Board of Zoning Adjustment
Staff Report
July 2, 2018

Case No:	16CUP1025
Project Name:	None
Location:	2071 South Preston Street
Owner(s):	Wettig Properties, LLC
Applicant:	Wettig Properties, LLC
Jurisdiction:	Louisville Metro
Council District:	15 – Marianne Butler
Case Manager:	Jon Crumbie, Planning & Design Coordinator

REQUEST(S)

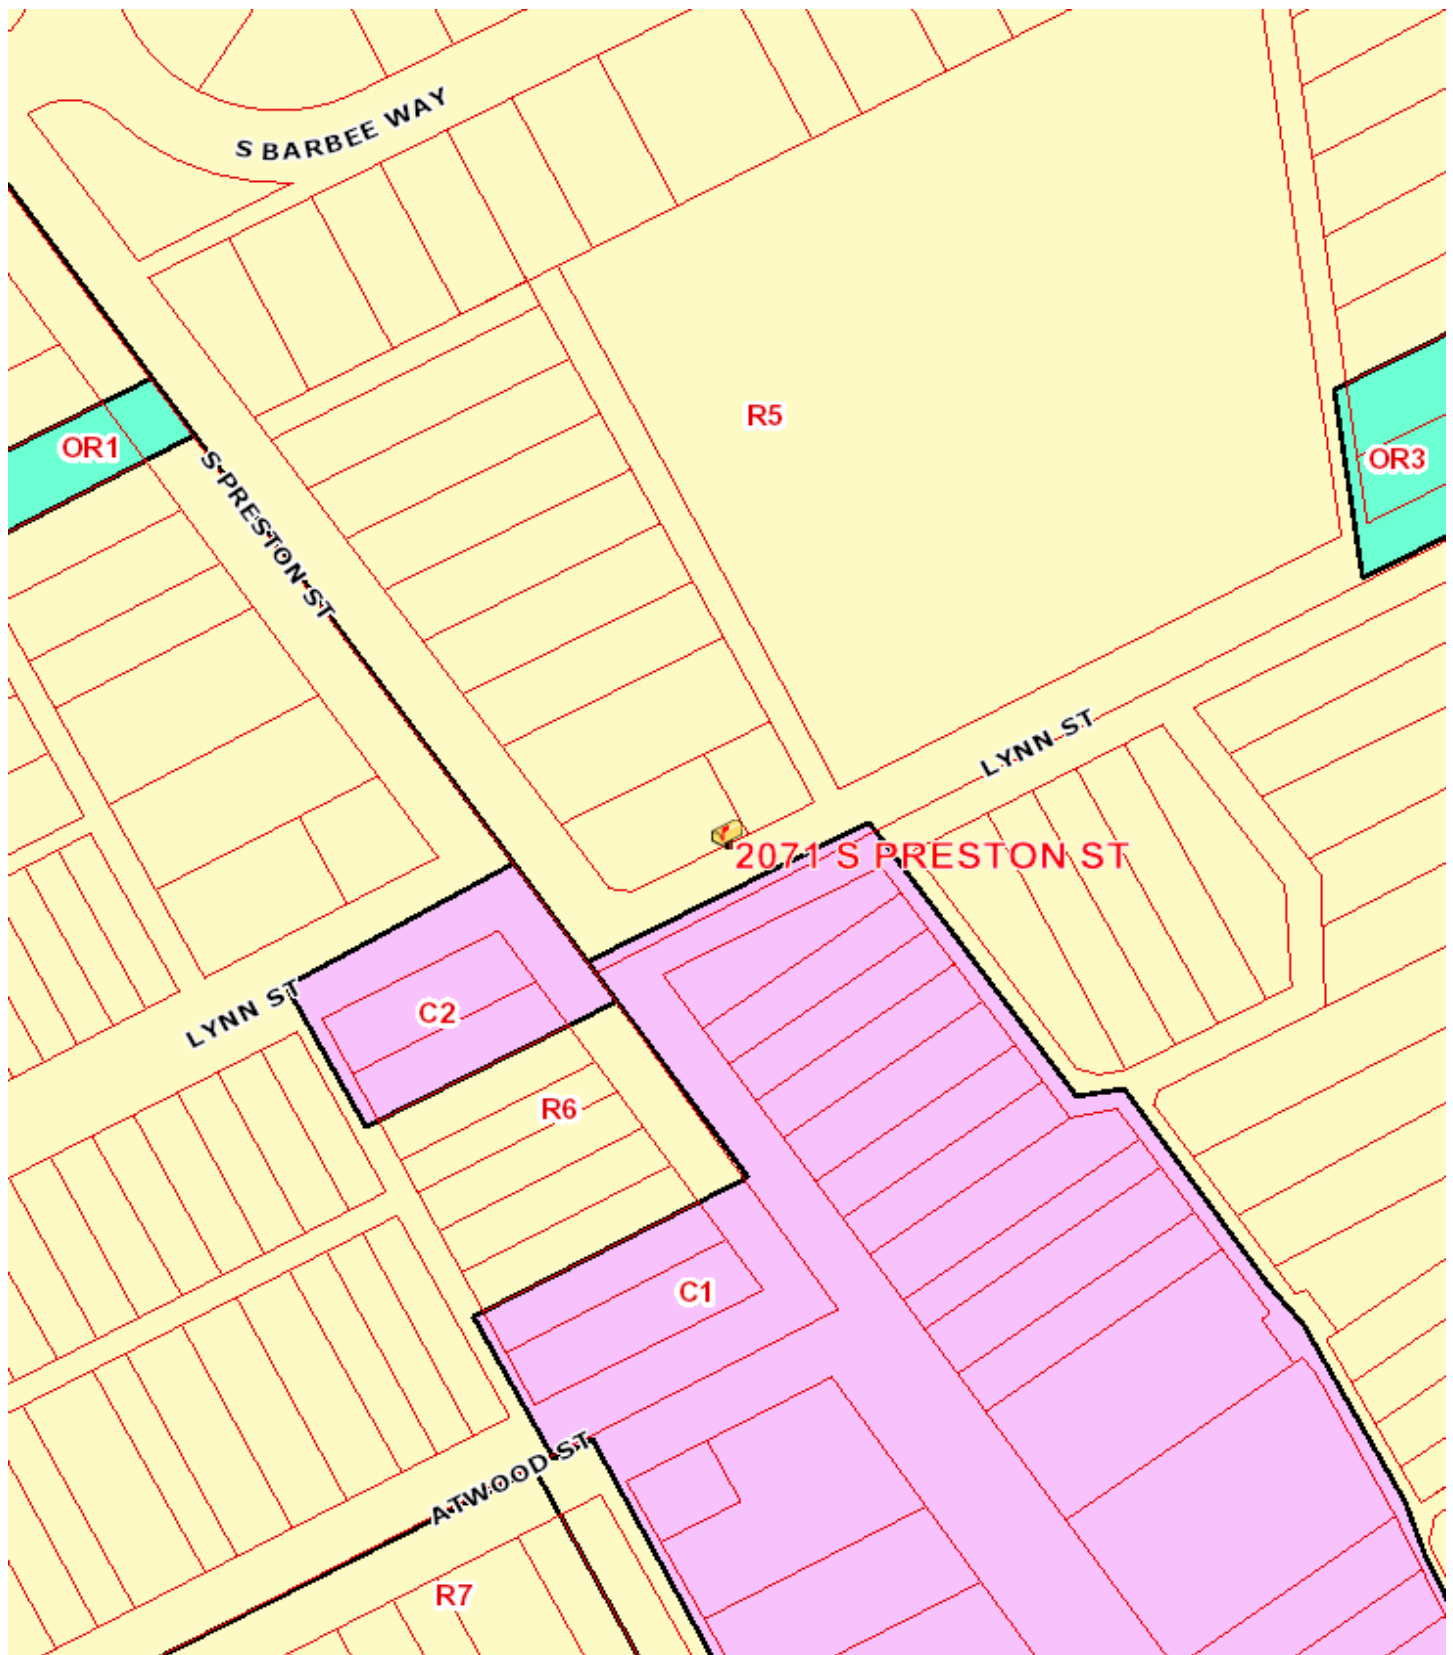
c. The minimum front, street side, and side yards required in the district shall be maintained free of parking. **The required front yard along South Preston Street is 15 feet. The parking/maneuvering area will be one foot from the front property line. The required side yard along the north property line is three feet. The parking/maneuvering area will be located on the property line. The required Lynn Street street side yard along the south property line is three feet. The parking/maneuvering area will be located two feet from the property line. The required rear yard along the east property line is five feet. The parking/maneuvering area will be located on the property line.**

STAFF: The strict application of the provisions of the regulation would create an unnecessary hardship on the applicant because the configuration of the parking lot would need to change and parking spaces could be lost.

STAFF: The strict application of the provisions of the regulation would create an unnecessary hardship on the applicant because the configuration of the parking lot would need to change and parking spaces could be lost.

STAFF: The strict application of the provisions of the regulation would create an unnecessary hardship on the applicant because the configuration of the parking lot would need to change and parking spaces could be lost.
